Land to south of Lane End, Penley, Wrexham

P/2014/0392

19th November 2014

I write in reference to the above planning application as the applicant's Arboriculturist who produced the original tree report dated 14th January 2014.

Tree Constraints Plan
Showing all trees,
tree categories and Root Protection Areas (RPAs)

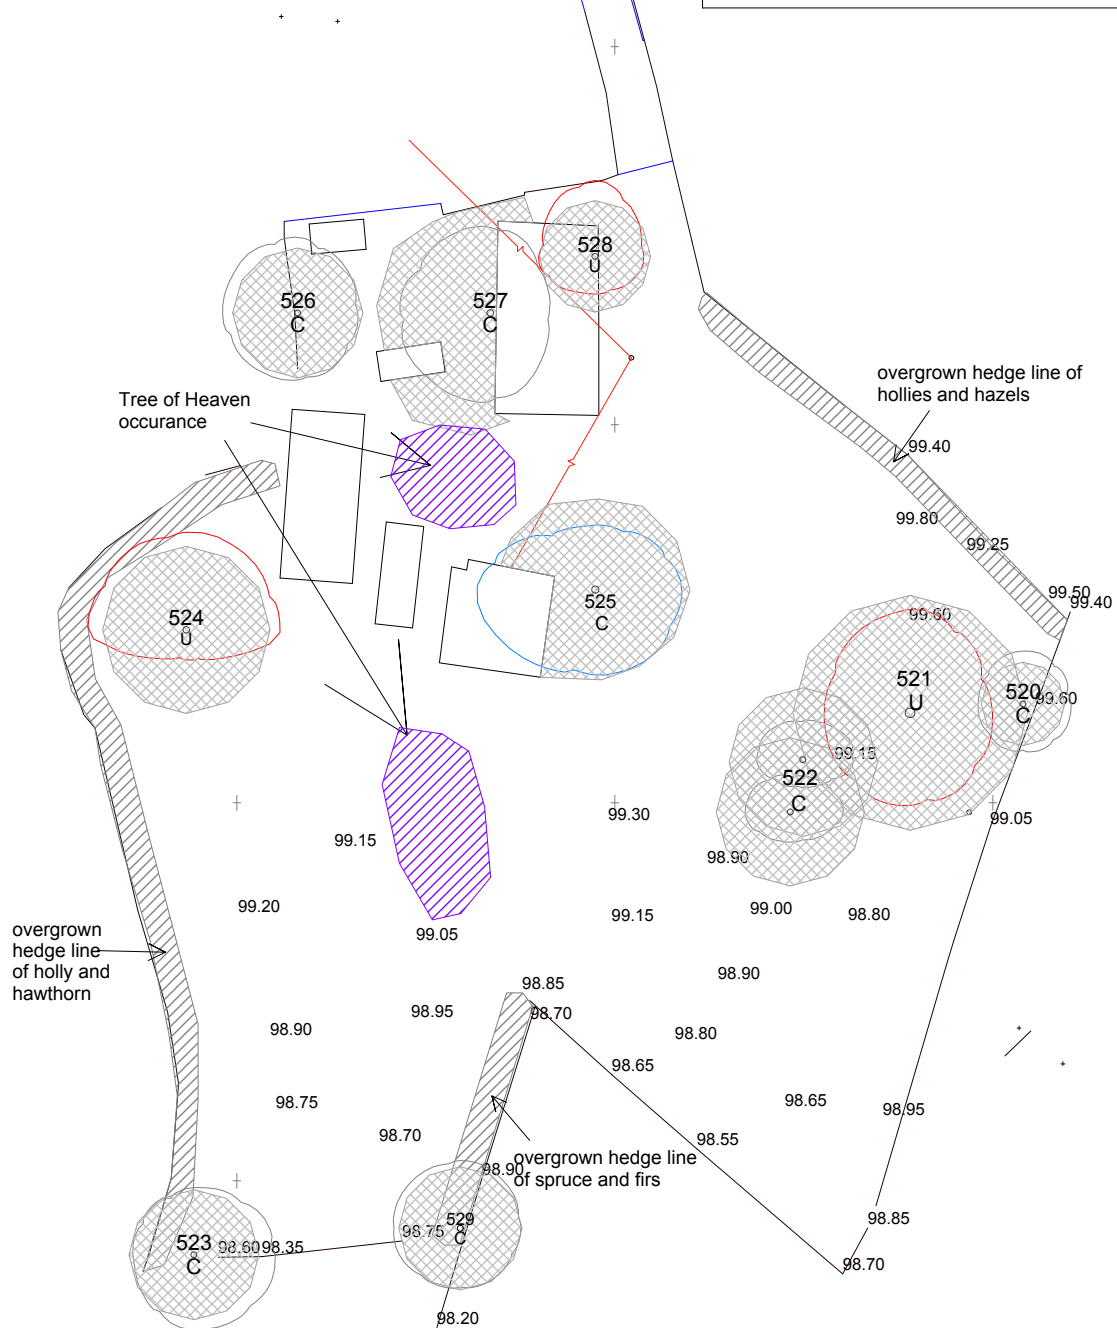
- 1) The overgrown hedgerow to the north east of the site was considered to be a line of trees rather than an overgrown hedgerow and required more attention to detail than I had provided.
- 2) Tree 521 was considered to be a significant tree and worthy of retention for its amenity value.
- 3) A multi stemmed hazel tree in the far south west corner had been missed from the survey and a building was planned to be very close to it.
- 4) Tree 525 was considered important and retention should be investigated.
- 5) Tree 527 was considered to be significant and should be upgraded to a higher category and retained.
- 6) More mitigation planting was required.

- 1) The Hedgerow to the north east is an escapee of what should be a hedge. At 8 metres high, it is becoming unsustainable as should it grow much higher it will start to die off at the bottom and the hazel stems will become unstable.

It would be better that these trees were cut back to a 3 metre high hedge line where they can be kept in this state for the benefit of both new owners and the houses behind the hedge.

To ensure a suitable root protection area (RPA) is given, the nearest planned house has been moved to allow an RPA of 3 metres from the boundary (essentially 2.5 metres from the trees). This is a more than adequate RPA for these hedgerow trees.

- 2) 521 is a large Goat willow tree and can be seen from a number of properties in the vicinity. Goat willows are short lived trees that have a propensity for failure when reaching maturity. This tree appeared to be in good health and had grown to a considerable size without failing. I was concerned about what appeared to be a large stem that had been removed from the tree on the northern side. I was apprehensive of decay spreading from this relatively new wound and also as there was a distinct lack of reaction wood around the entire wound.

When I revisited the site I used a rubber mallet to sound out any perceived decay pockets. I detected a long area of unsound wood leading up the right stem indicating that internal decay was moving up this stem. I did not detect any other dysfunctional area. It won't be long before this branch breaks and it will be certainly exacerbated by the removal of the large macrocarpas next to it as wind dynamics around the tree will change and failures will be more likely.

Given the poor compartmentalisation attributed to all willow trees I would expect this decay to spread to the other two stems in the near future and would expect a major failure within 10 years. I have therefore re-categorised this tree as a Cat U tree to be removed.

- 3) The hazel tree to the far south east has been plotted and give a number of 529. The garage that would have been on this trees RPA has been removed from the plan.
- 4) We were very conscious of trying to save at least one of the significant trees on site and 525, the weeping willow appeared to be the easiest to retain. With careful removal of the building next to it, improvement of the exposed soil, some pruning of the tree and the use of a Three dimensional cellular confinement system (TDCCS) with a porous surface dressing, the tree could be retained and provide a central feature to the cul-de-sac.

- 5) I disagreed that 527 was a tree anything other than a C category tree. It was quite visible from the north but apart from this, the views of it were unremarkable (Picture 4).
